From: Web NoReply
Sent: Monday, May 5, 2025 12:13 PM
To: City Council
Subject: Comments - Sherry Tarasoff - College Drive Bus Rapid Transit Link Concept Changes
Attachments: BRT on College.pdf

What agenda item do you wish to comment on ?: 6.2.3 College Drive Bus Rapid Transit (Link) Concept Changes

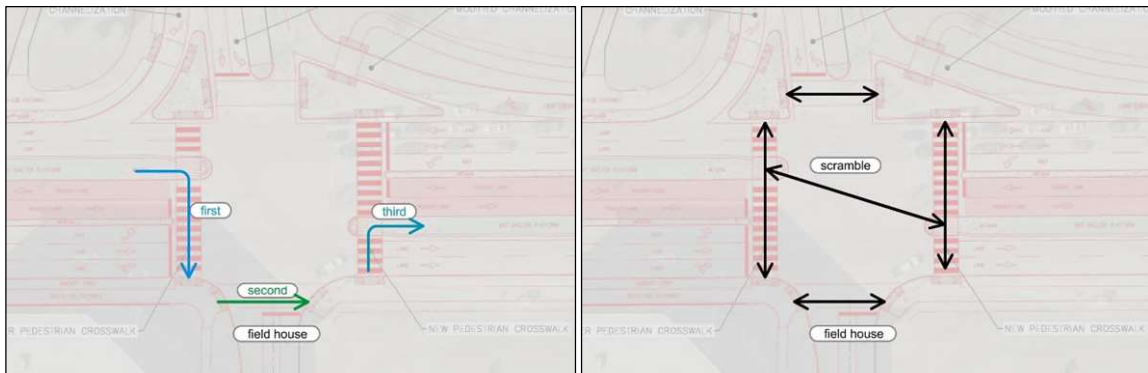
1. On "Munroe Avenue Looking West", what do the four lights on the transit signal mean?
2. On "Looking East Toward Bottomley Avenue", there is a bus within eastbound traffic. Will other non-BRT transit network routes still be within traffic on College Drive?
3. When the final design of the shelters for the platforms is determined, will feedback be sought from the public? On "Campus Drive Looking East", it appears that there is no space behind the shelter and that there is limited space in front of the shelter to move about.
4. Many of the images show the large information display between the shelter and the direction that the bus is coming from, obscuring the view for waiting riders. Is that the final configuration?
